FIELD INSPECTION

Project Name:	Mountain Valley Pipeline	Inspector:	Matthew Grant
Inspection Date:	Wednesday, March 13, 2019	Project Contact:	Brian Clauto
Spread: Franklin County MP 251-252	Spread H	Weather (Wet/Dry/Rain):	Dry

FIELD INSPECTION PHOTO LOG

- Fig. 1 St#13299+30 sump end treatment falling into sump

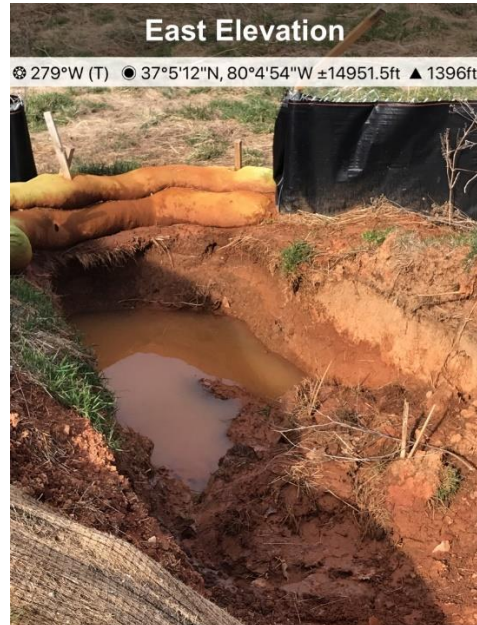
- Inspected designated streams included: S-GH11, S-GH9. ECD were in place near all the streams, no impacts were observed at the time of the inspection.
- St#13299+30 sump end treatment falling into sump
- St#13033+30 sump has had soil collapse in to storage area
- St#13326+35 water bar flow path requires repair and end treatment is undermined
- St#13331+75 triple stack is undermined

Recommended Corrective Action: Maintain all controls per the annual standard and spec
